ADDENDUM NO. 3

RE: **Athletic Performance Addition**
Perkinston Campus, MGCCC
Perkinston, Mississippi
A/E Project No. 26-028a

FROM: EGH Architects
1091 Tommy Munro Drive
Biloxi, MS 39532
(228) 594-2323

2 ONE-LINE DIAGRAM
E-000 SCALE: NONE

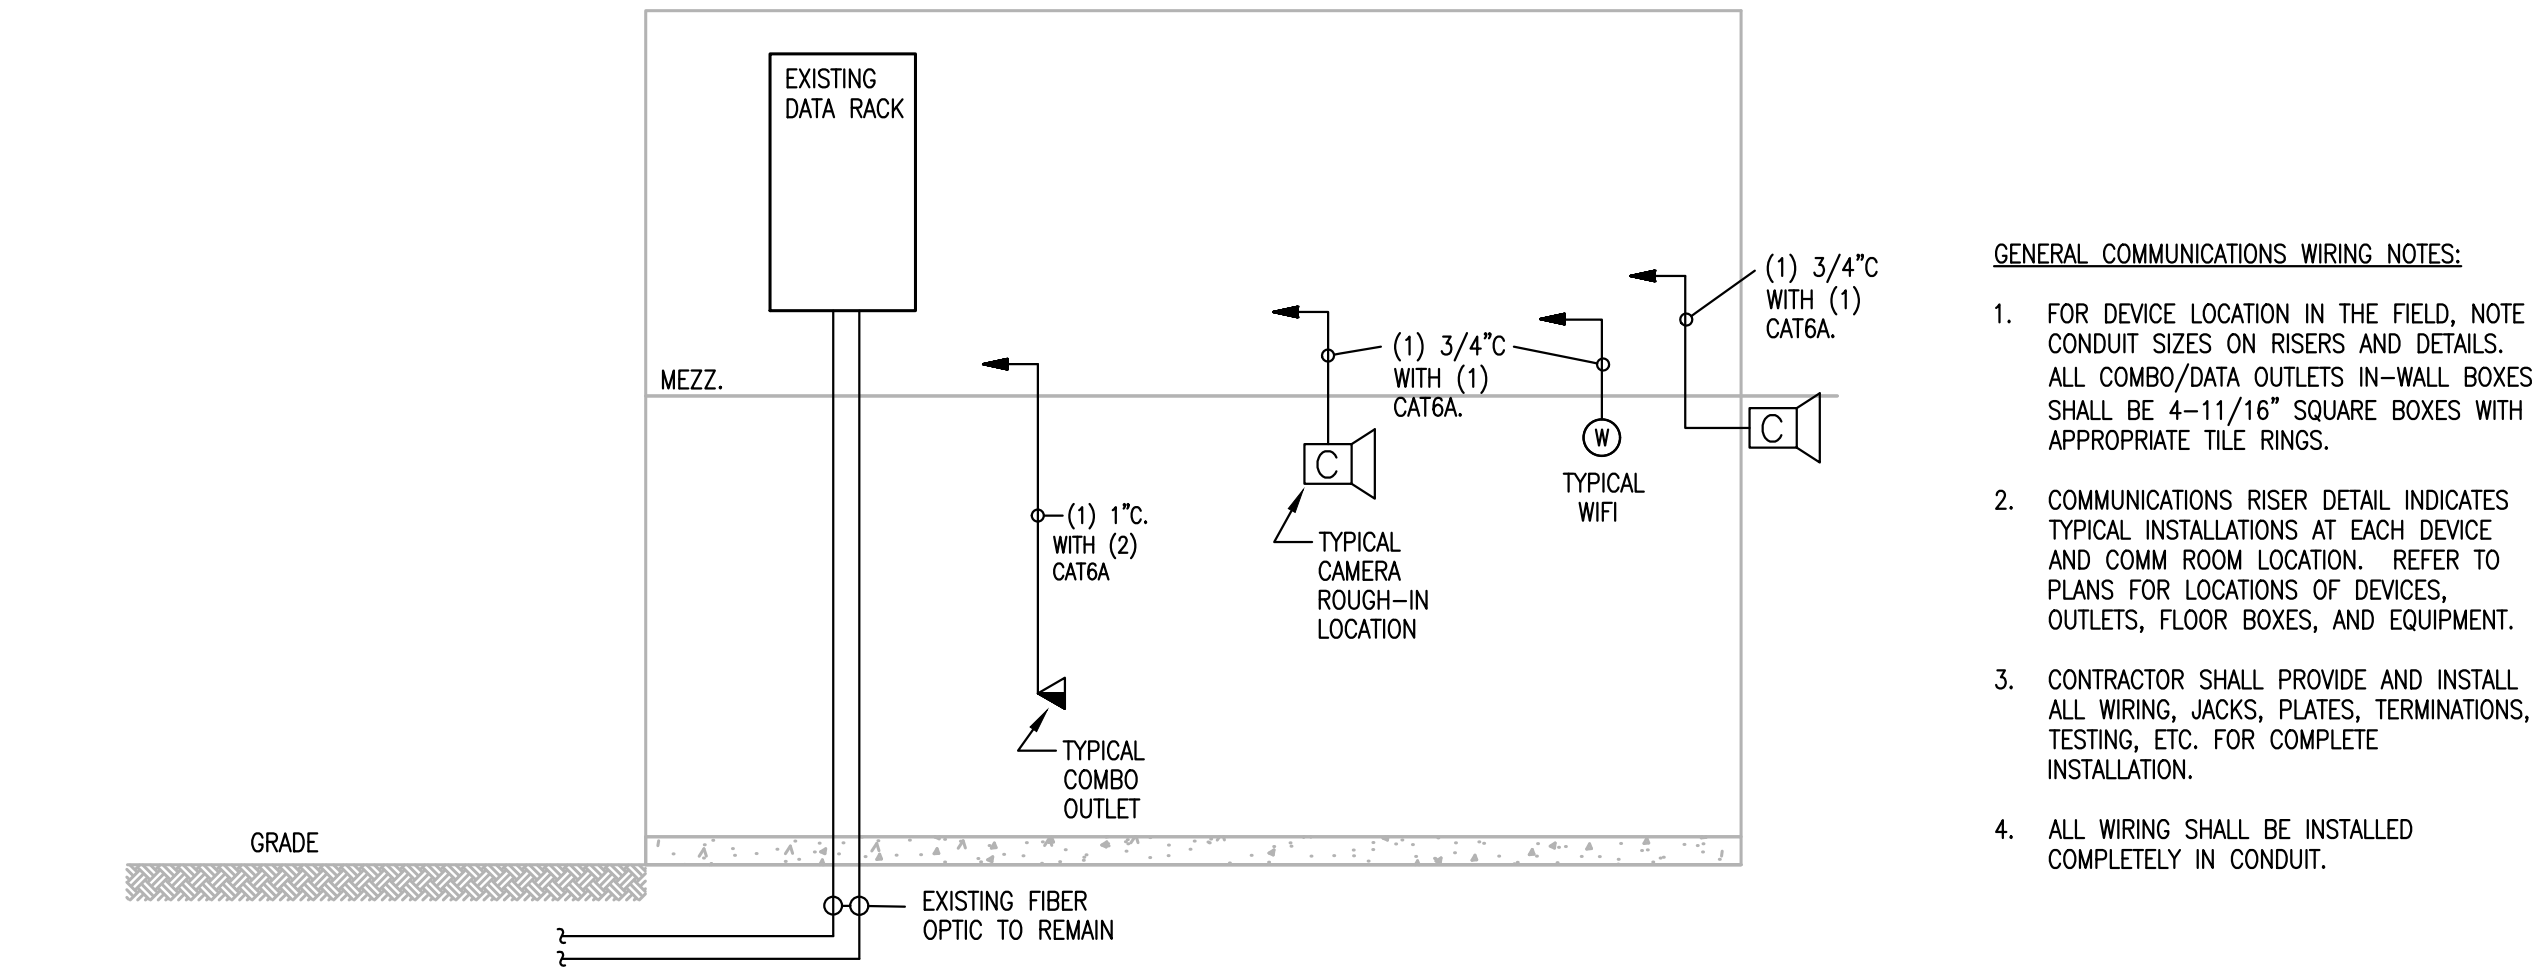
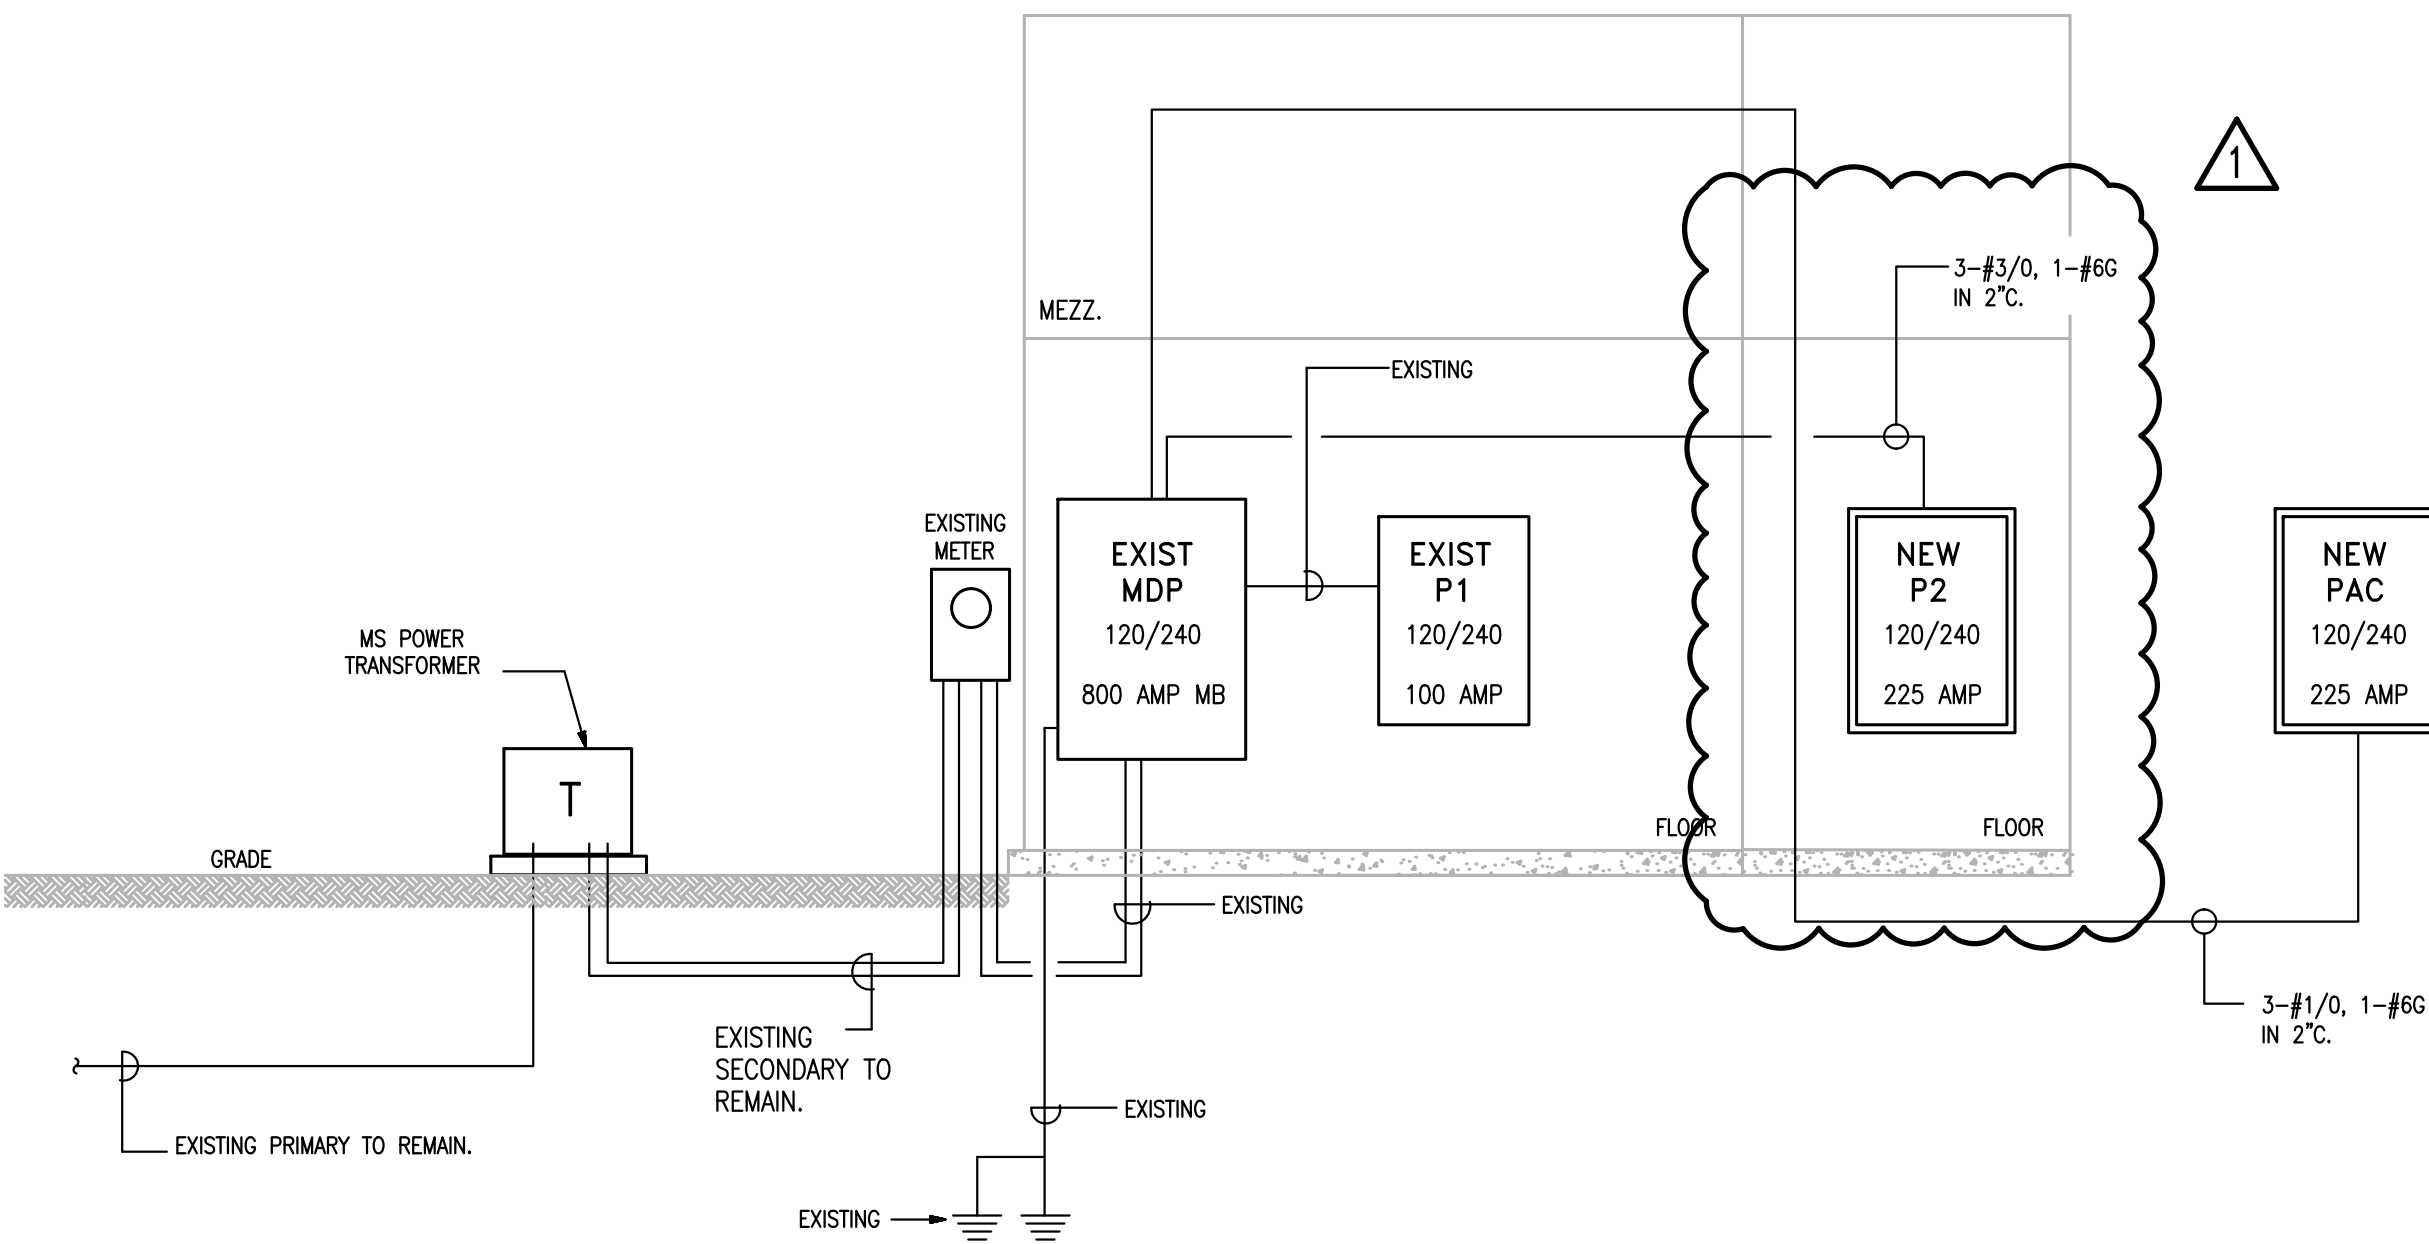
5. Electrical Revisions:
 - a. Sheet E000 – One Line Diagram
 - i. Revise Panel "P2" and feeder.
 - ii. Remove and replace with attached Sheet E000R.
 - b. Sheet E203 – Mezzanine Electrical Plan

1 MEZZANINE ELECTRICAL PLAN
E-203 SCALE: 1/8" = 1'-0"

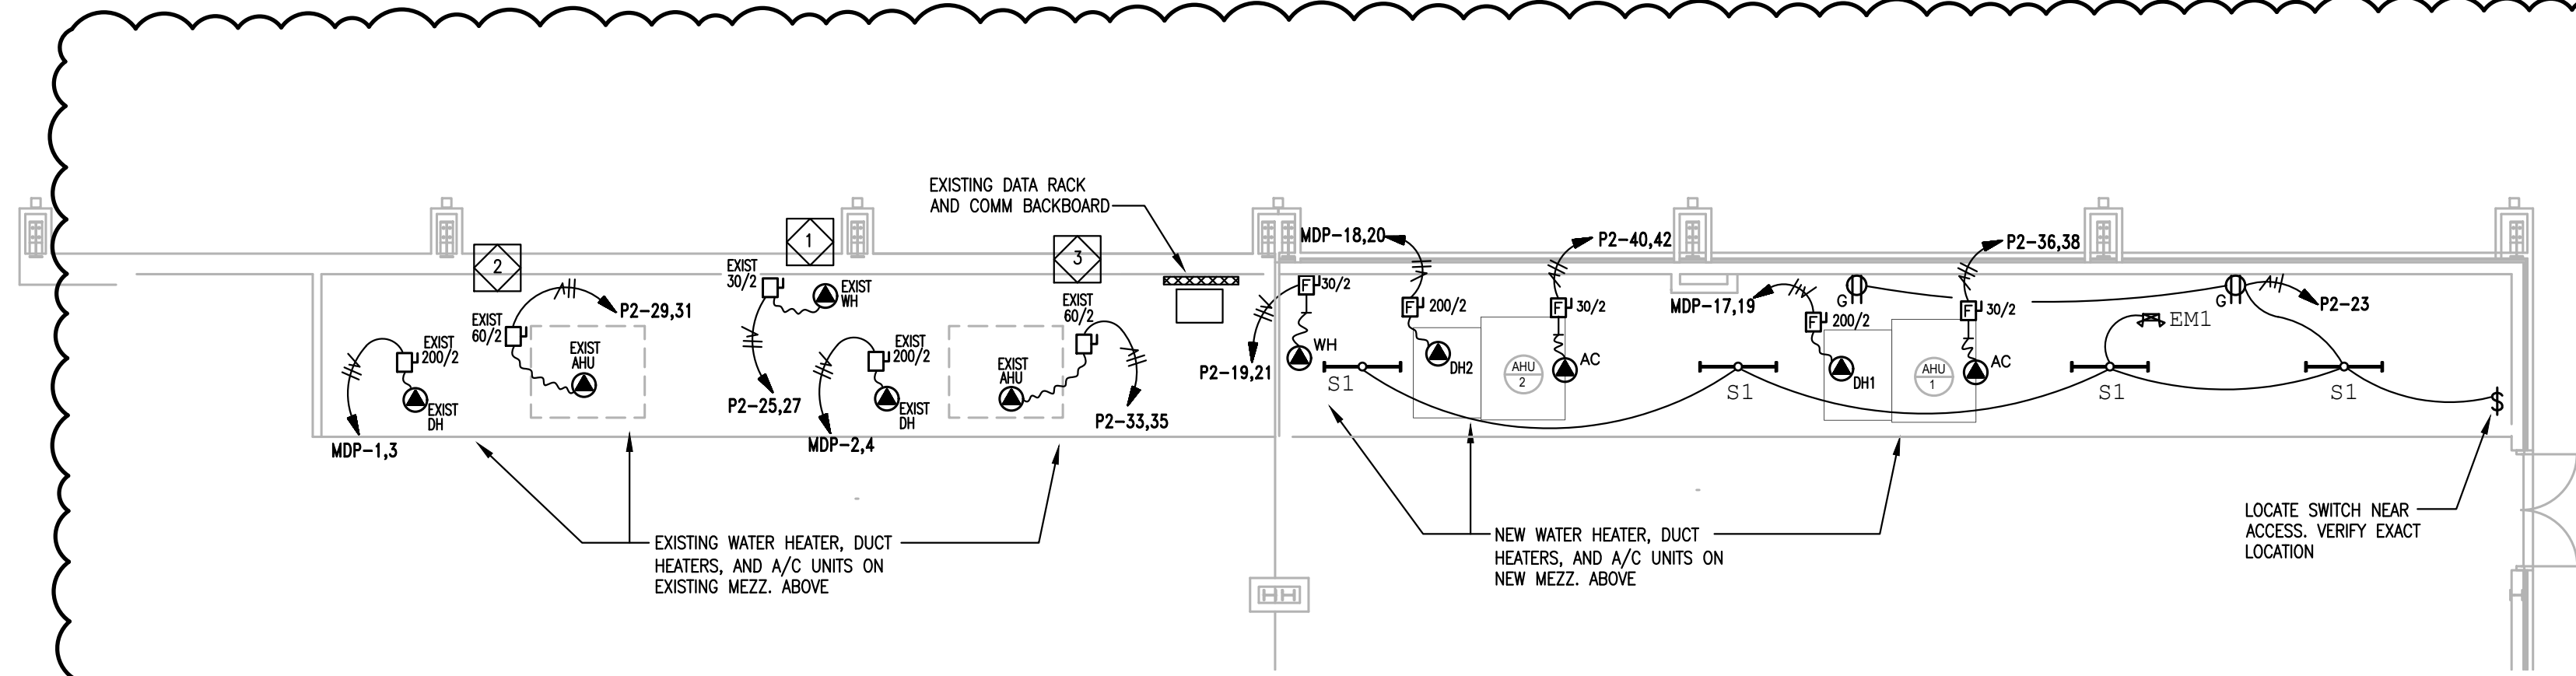
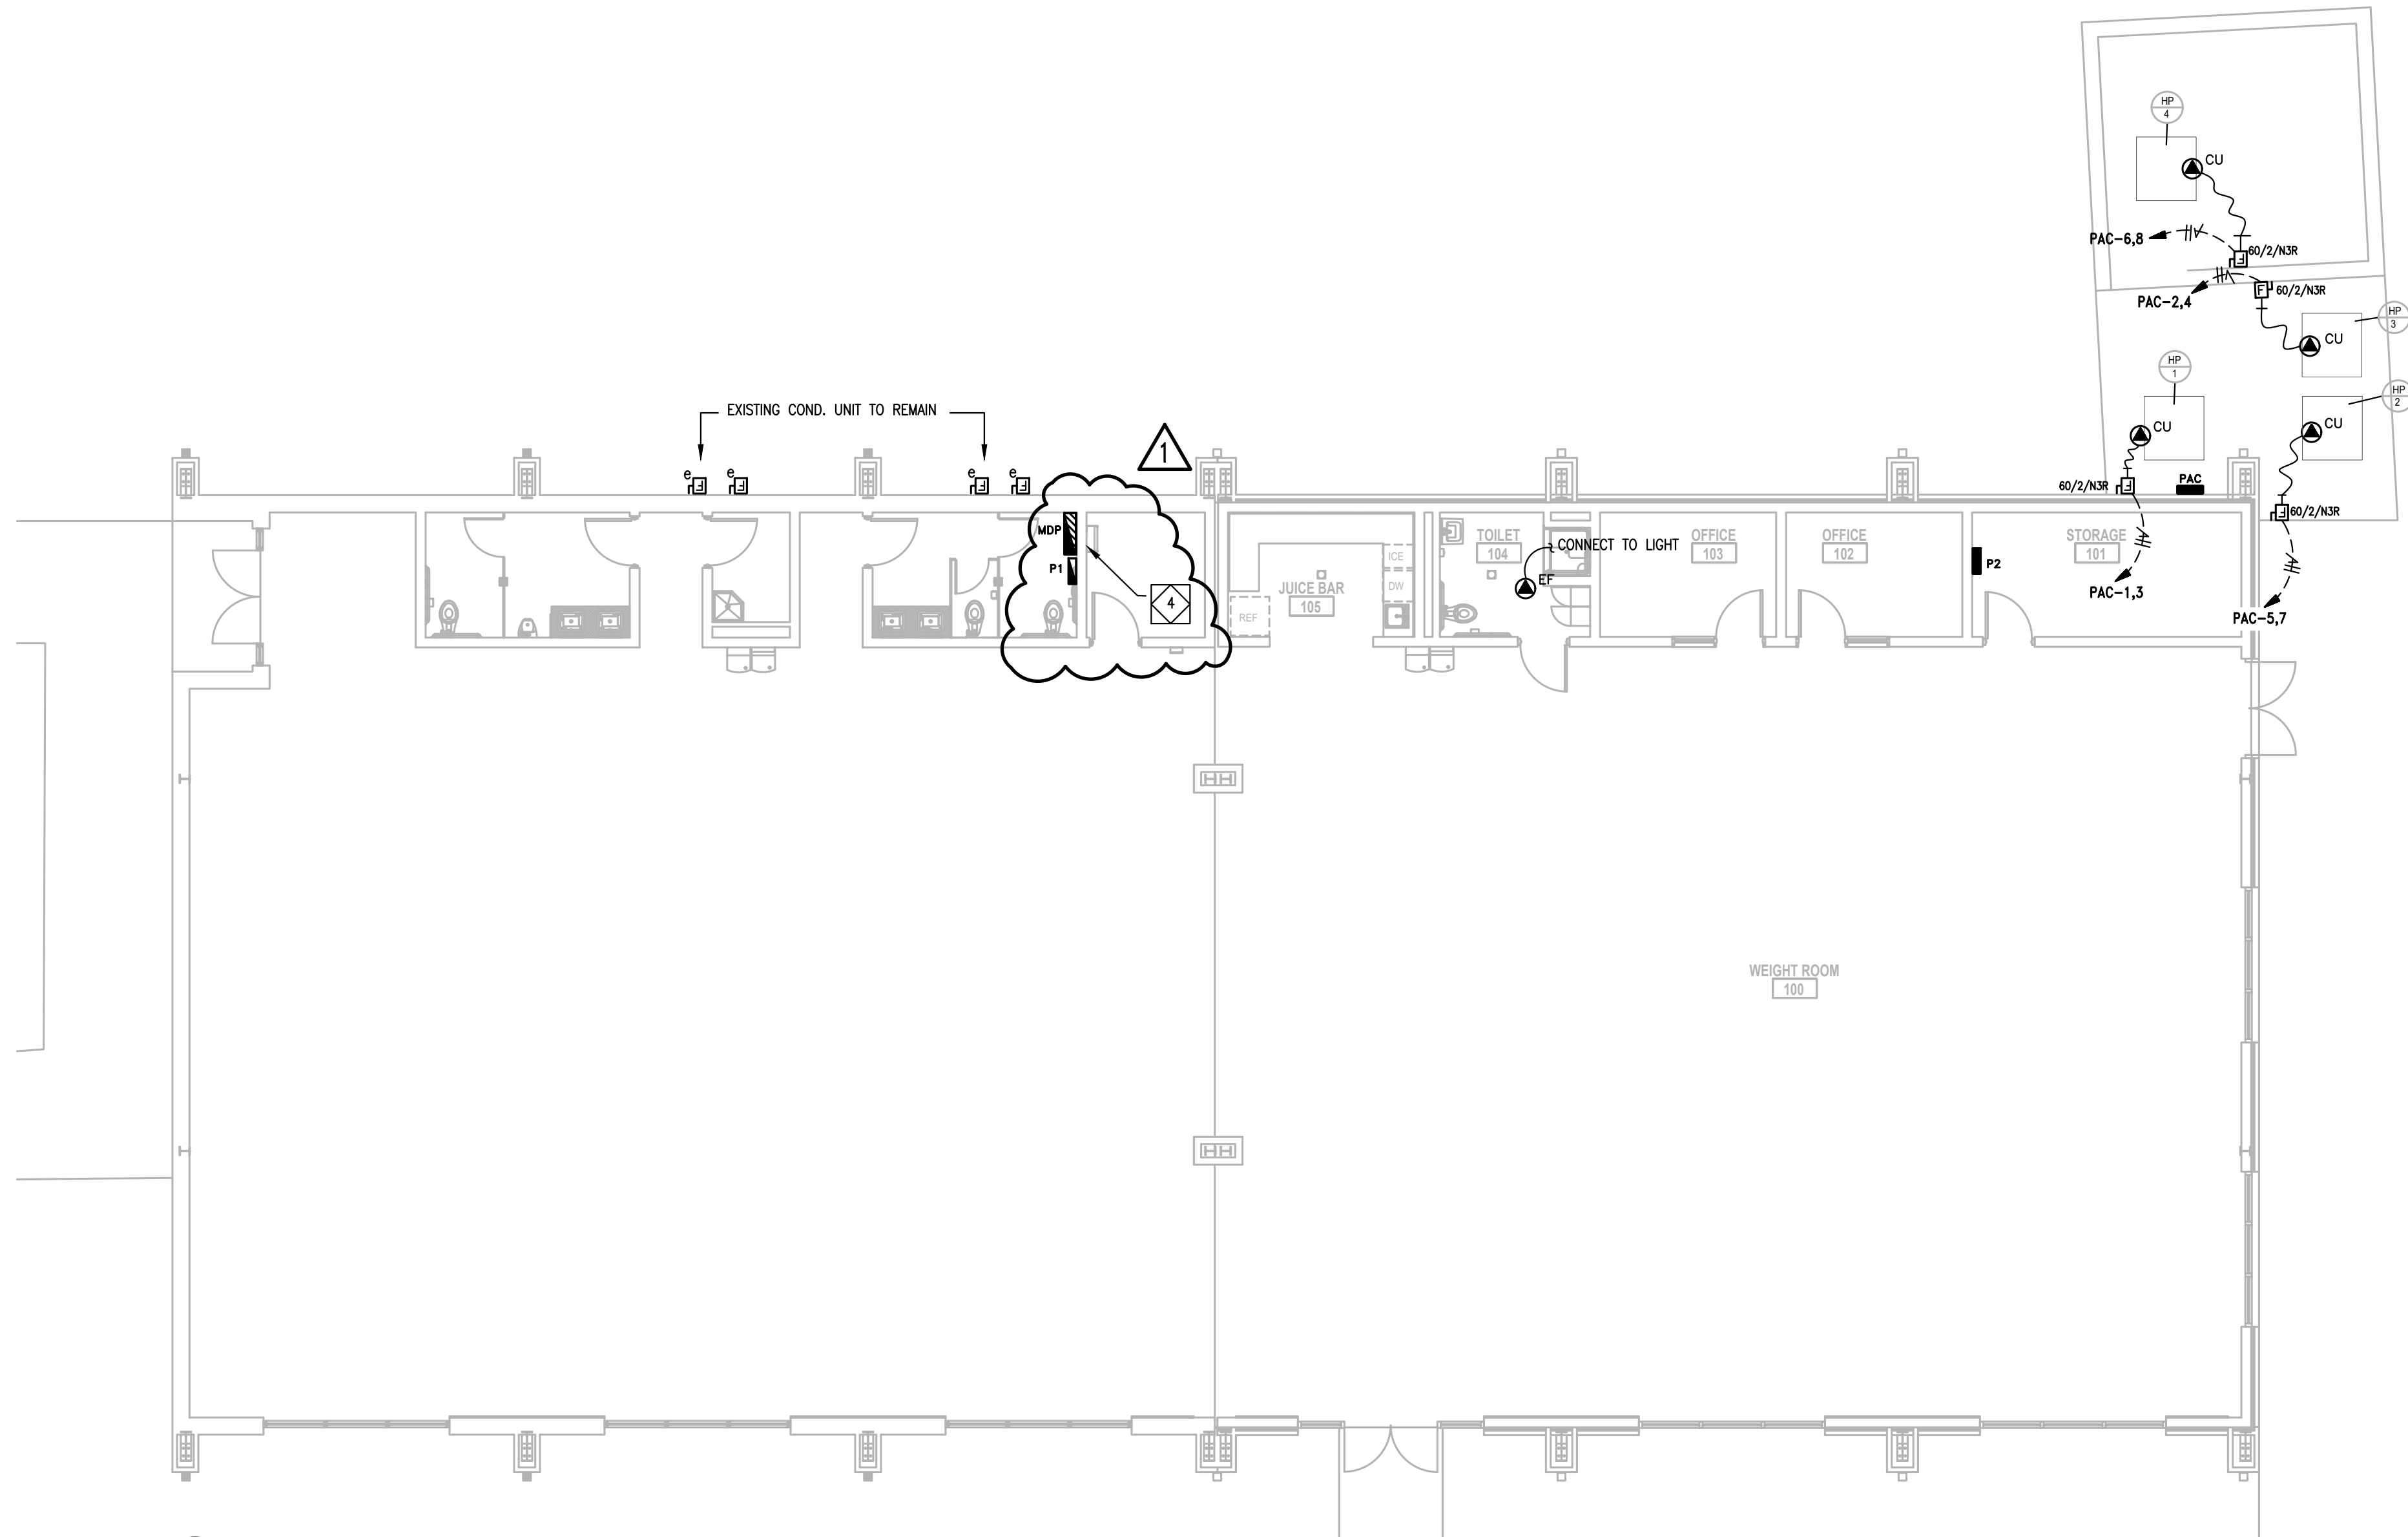
- i. Demo existing circuits for existing water heater and (2) existing air handler units.
 - ii. Reconnect existing water heater and (2) existing air handler units to new Panel "P2".

- iii. Add (1) type "EM1" light at new Mezzanine.
 - iv. Revise circuits for new air handler units AHU/1 and AHU/2.
 - v. Add circuits for new duct heaters DH/1 and DH/2.

- vi. Add Specific Notes.
 - vii. Remove and replace with attached Sheet E203R.
 - c. Sheet E301 – Electrical Panel Schedules
 - i. Revise Existing Panel "MDP".

- 1 DEMO EXISTING HOMERUN CIRCUIT FOR EXISTING WATER HEATER TO PANEL "MDP". INSTALL CIRCUIT TO PANEL "P2" AS NOTED.
- 2 DEMO EXISTING HOMERUN CIRCUIT FOR EXISTING AHU #1 TO PANEL "MDP". INSTALL NEW CIRCUIT TO PANEL "P2" AS NOTED.
- 3 DEMO EXISTING HOMERUN CIRCUIT FOR EXISTING AHU #2 TO PANEL "MDP". INSTALL NEW CIRCUIT TO PANEL "P2" AS NOTED.
- 4 REMOVE EXISTING 30A/2P WATER HEATER BREAKER AND (2) EXISTING 40A/2P AHU BREAKERS TO ALLOW FOR INSTALLATION OF NEW BREAKERS
